DOCUMENT CHANGE REQUEST

DCR number 473	Changes required for: General	Originator: Steve Thacker - ESCC
Date: 2009/02/06	Date sent: 2009/02/06	Organisation: ESA/ESTEC
Status: IMPLEMENTED

Title:	Connectors Electrical Rectangular Non-Removable Solder Bucket PCB and Wire-Wrap Contacts		
Number:	3401/001	Issue:	3

Variant 25

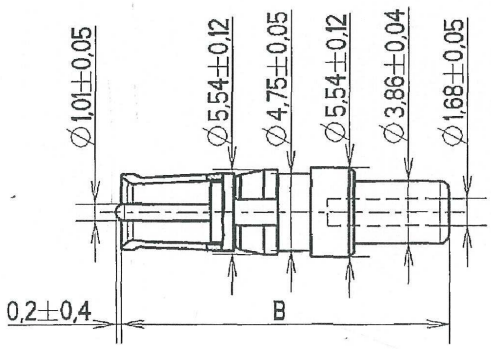
Figure 2, Add new figure for Variant 25 for Male/Female Coaxial Contact (with Female/Male Centre Contact). See attached.
Add Variant 25 Dimension B = 20.20mm to dimension table (all other dimensions: '-').

FIGURE 2(d) – SAVERS TYPE

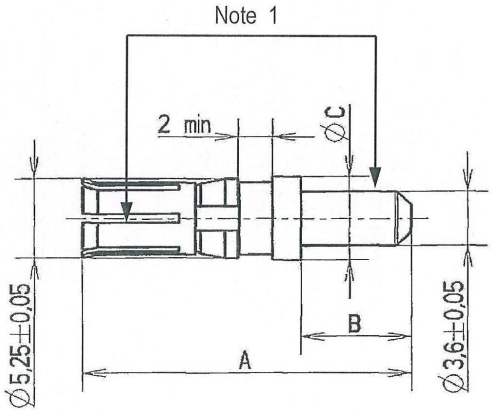
Figure 2, Add new Figure 2(d) for Variant 17 for Male/Female Contact (with Female/Male Centre Contact). See attached. (renumber subsequent figures as Figure 2(e))
